ADDENDUM

PROJECT: DOT-200009 Putnam County FSMF

ADDENDUM NO.: 2

PUTNAM COUNTY FSM FACILITY FOR OHIO DEPARTMENT OF TRANSPORTATION

C3.2
UTILITY PLAN

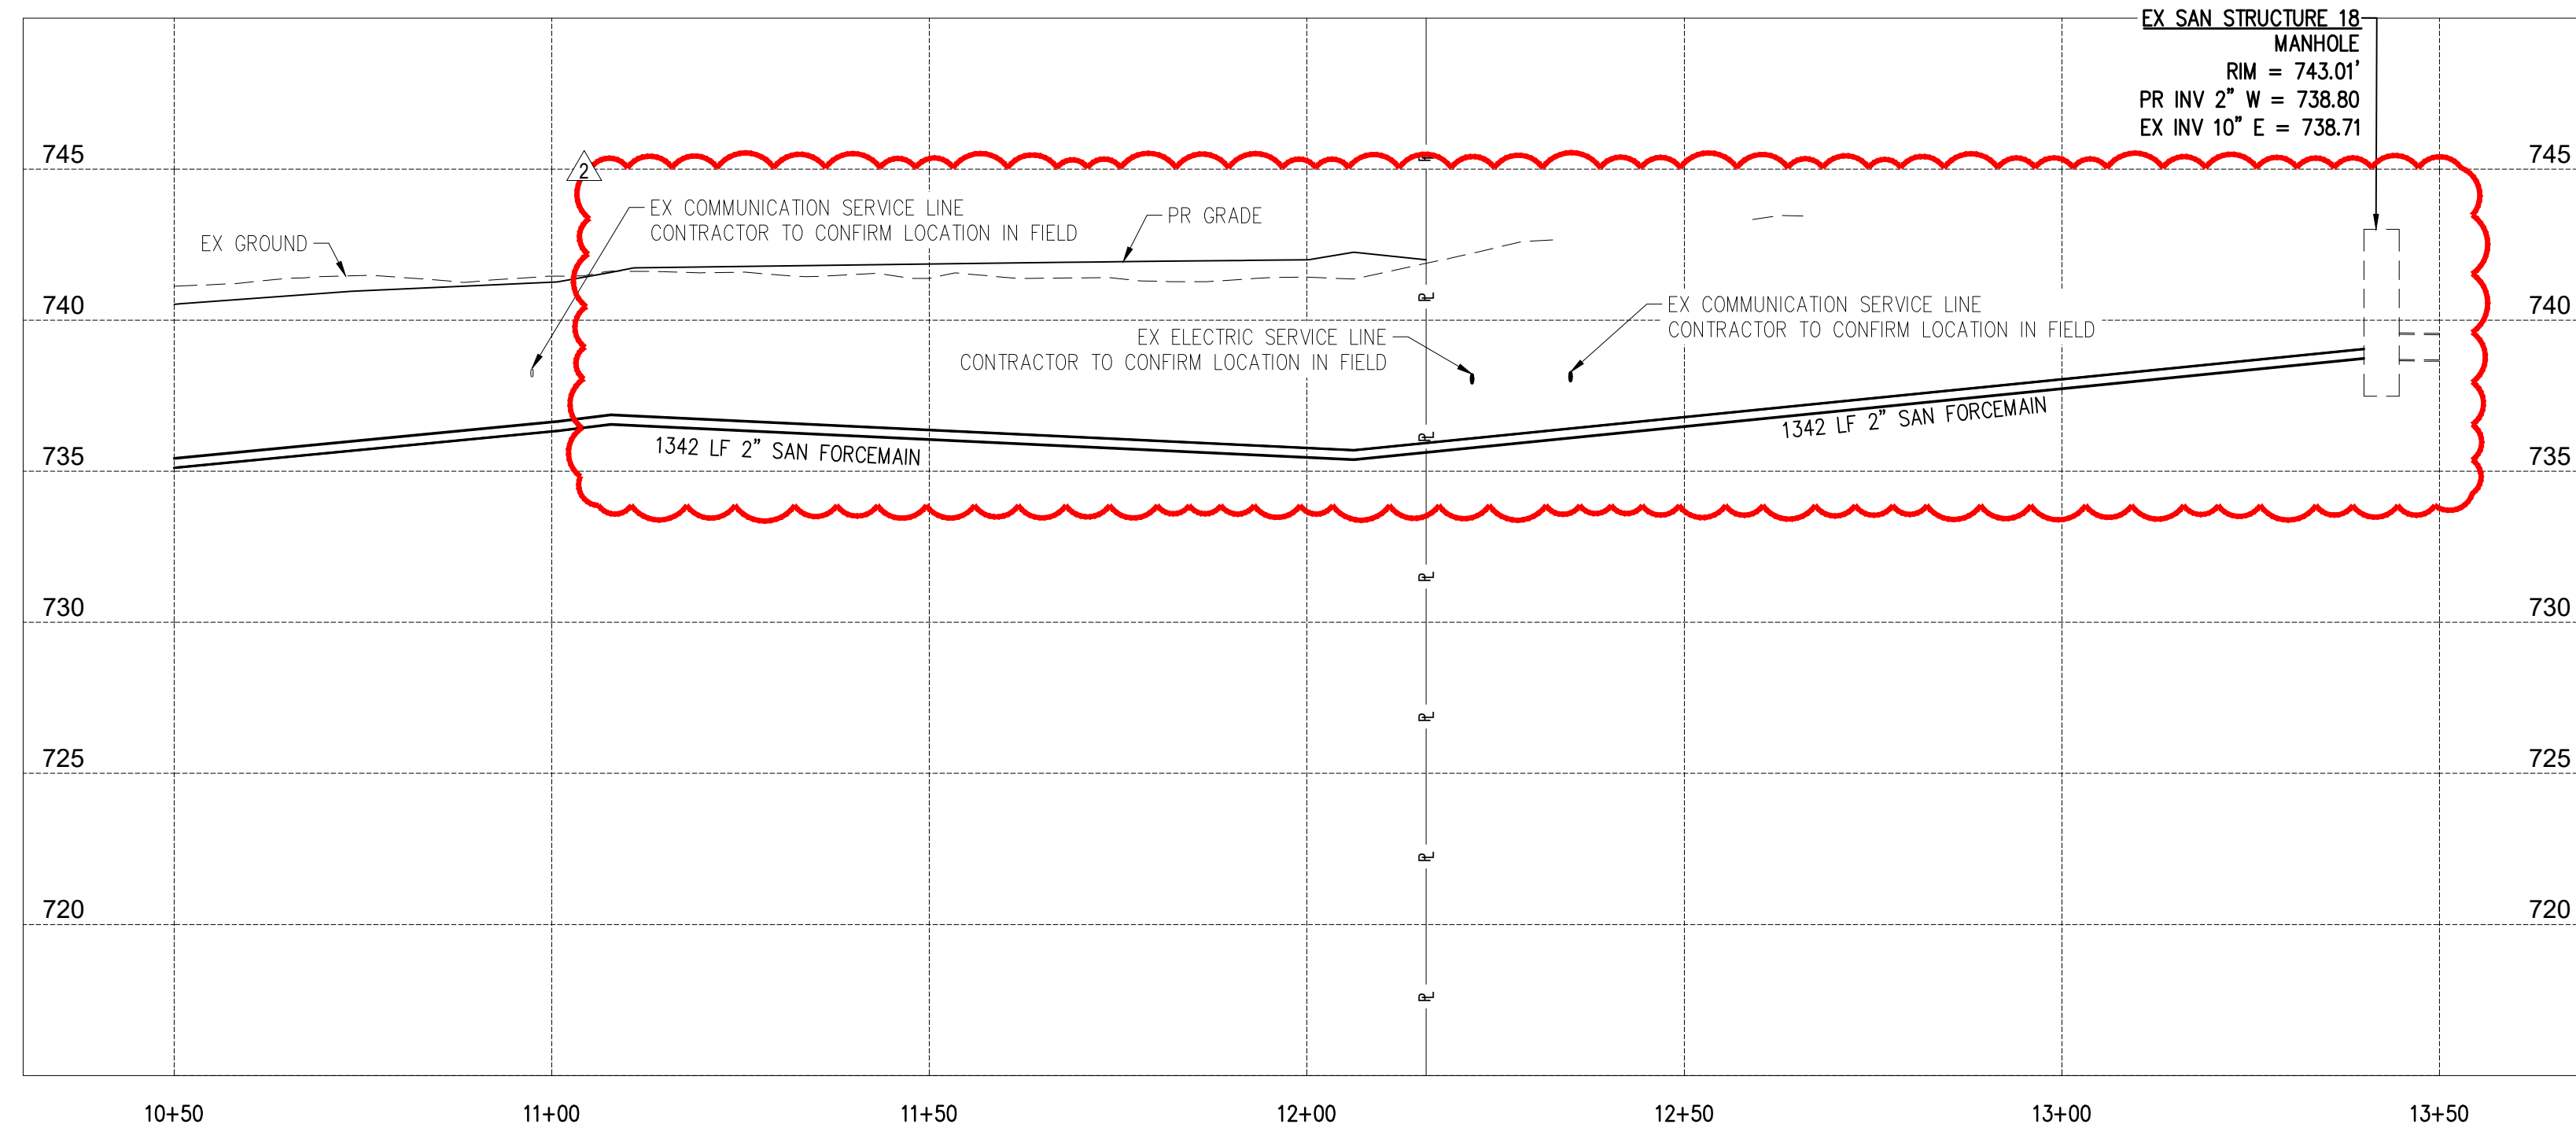
- Revision: Sanitary MH #14 removed, 8" gravity sewer segment Q removed, force main extended to existing sanitary MH #18

BID DOCUMENTS
C3.6
 UTILITY PROFILES

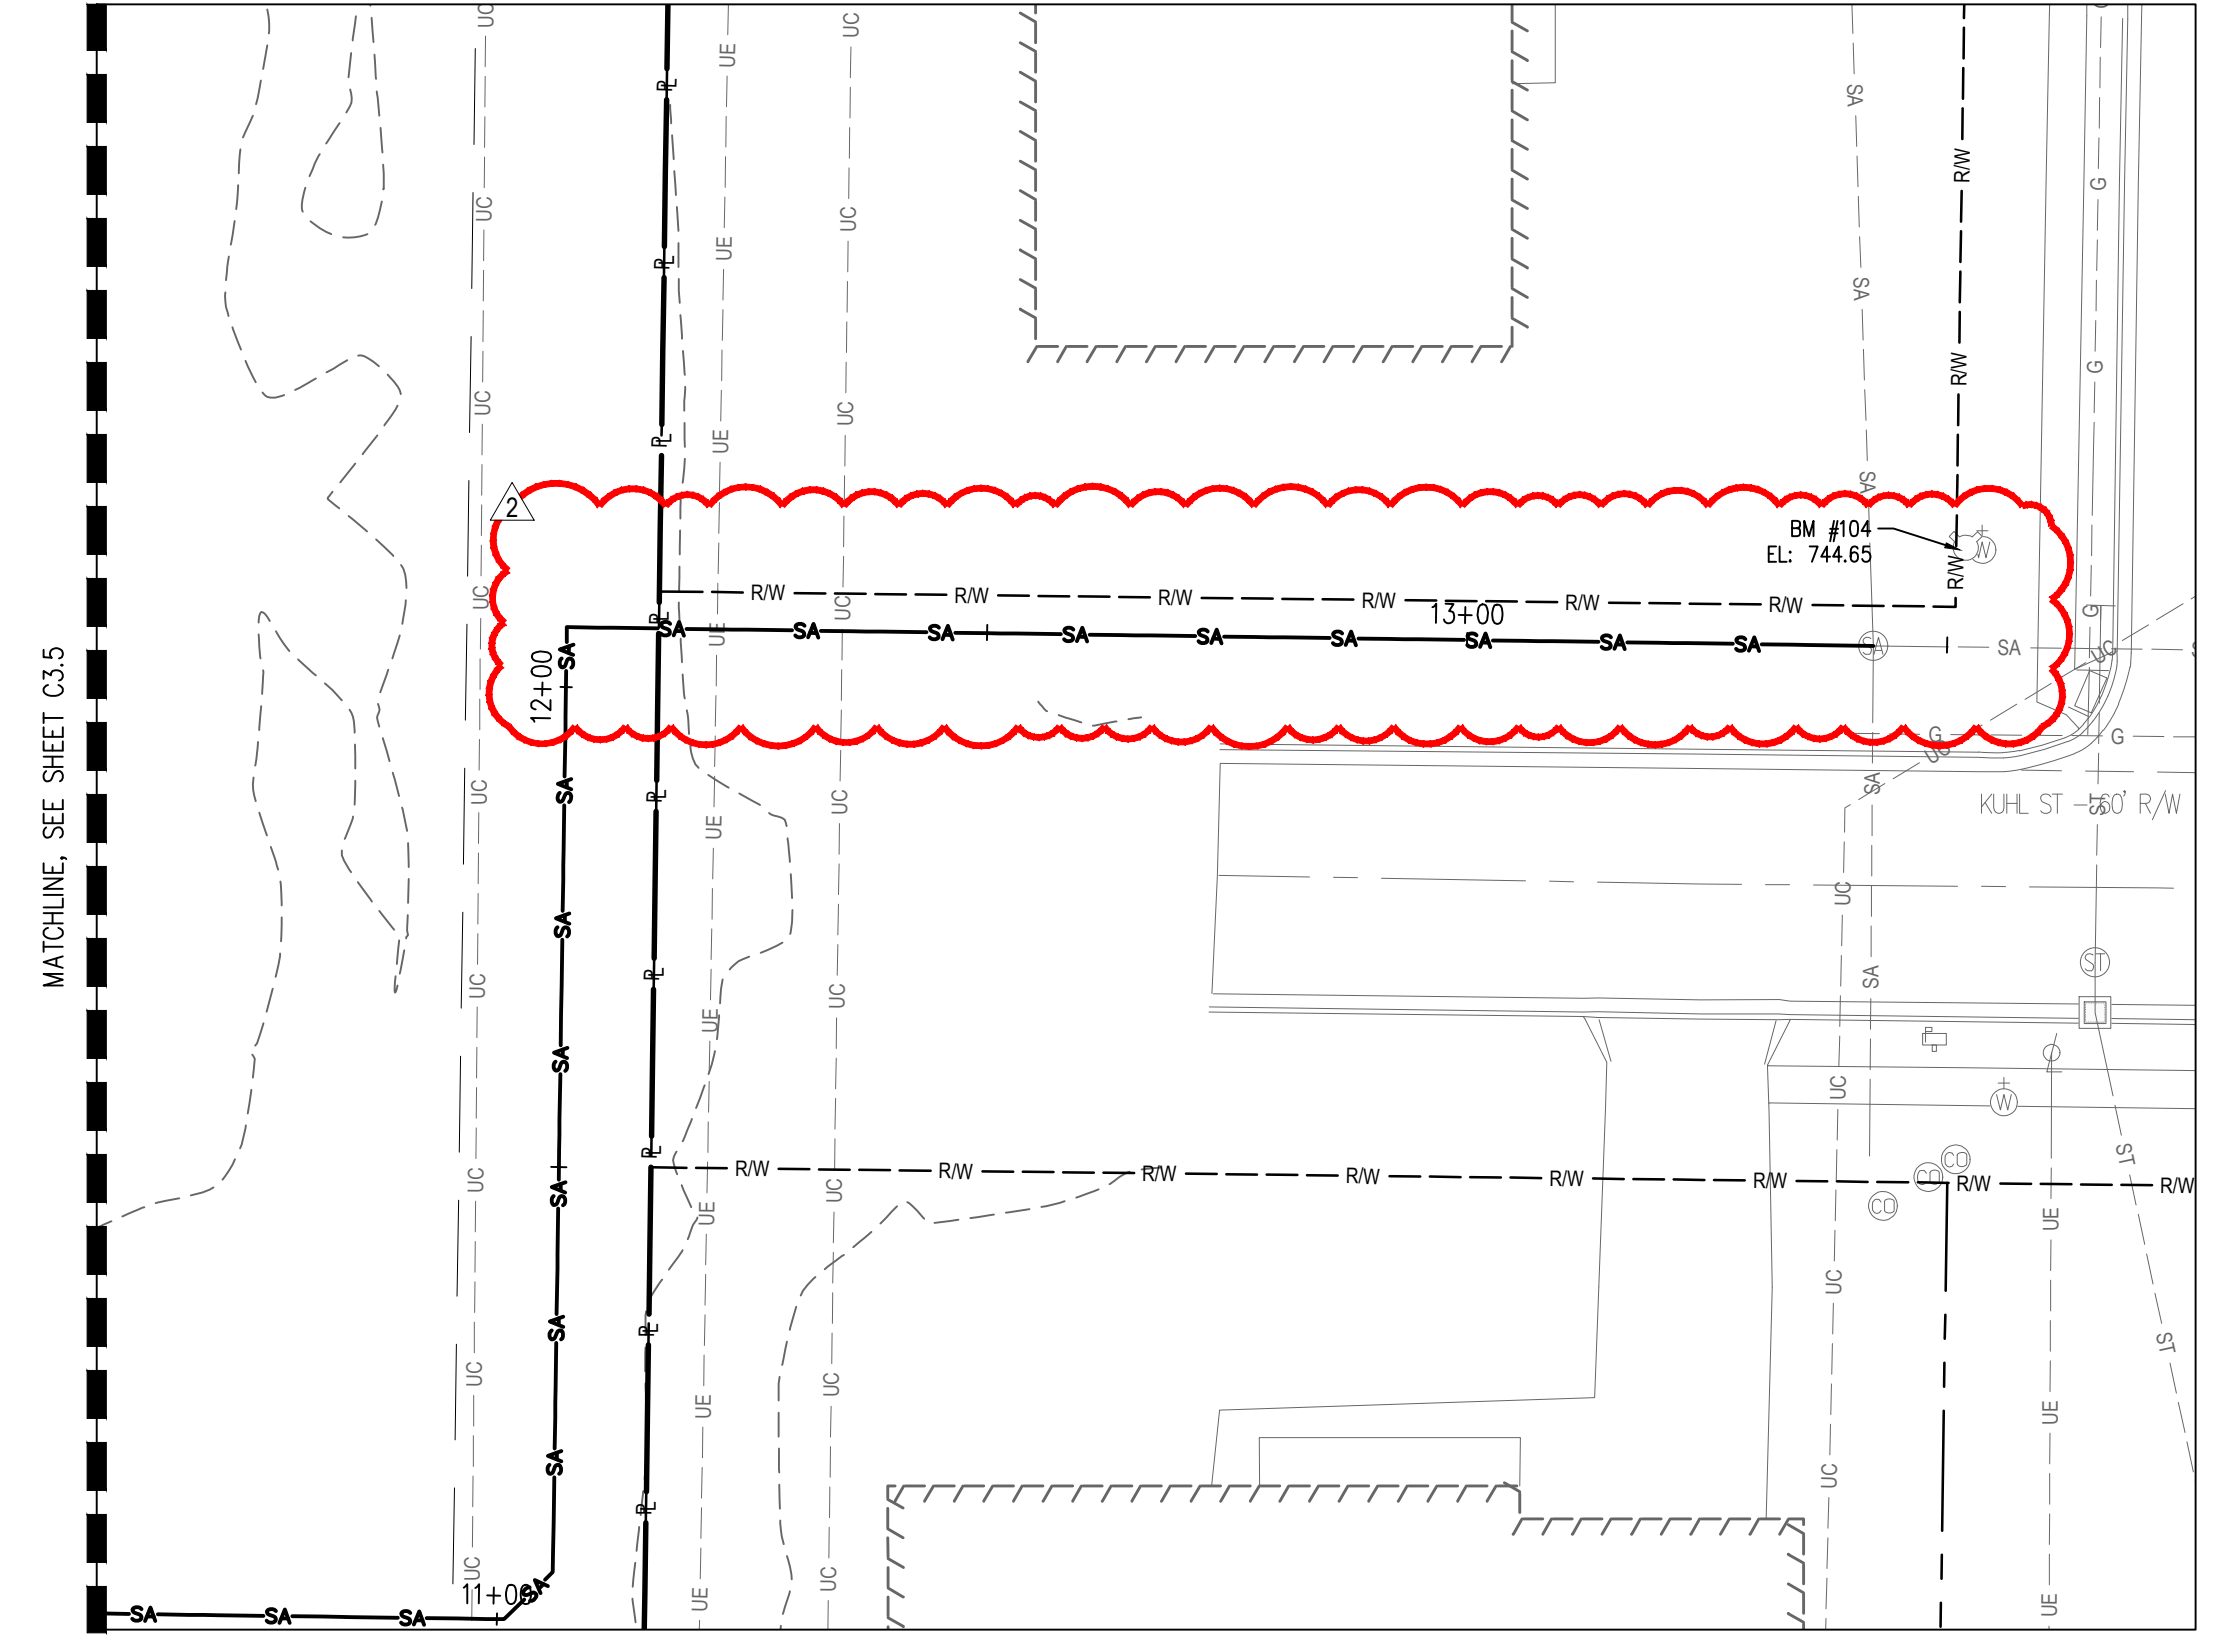
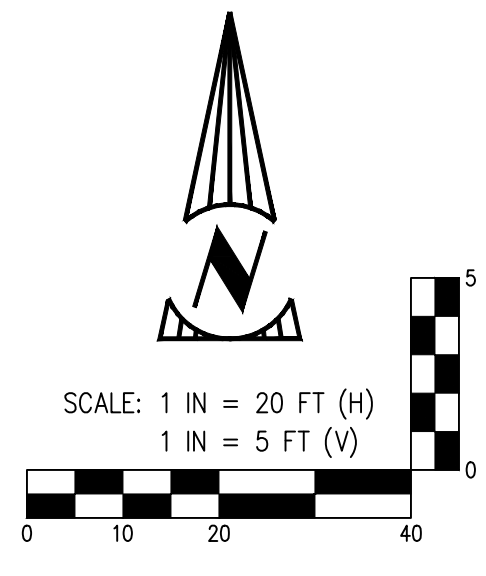
- Revision: Sanitary MH #14 removed, 8" gravity sewer segment Q removed, force main extended to existing sanitary MH #18
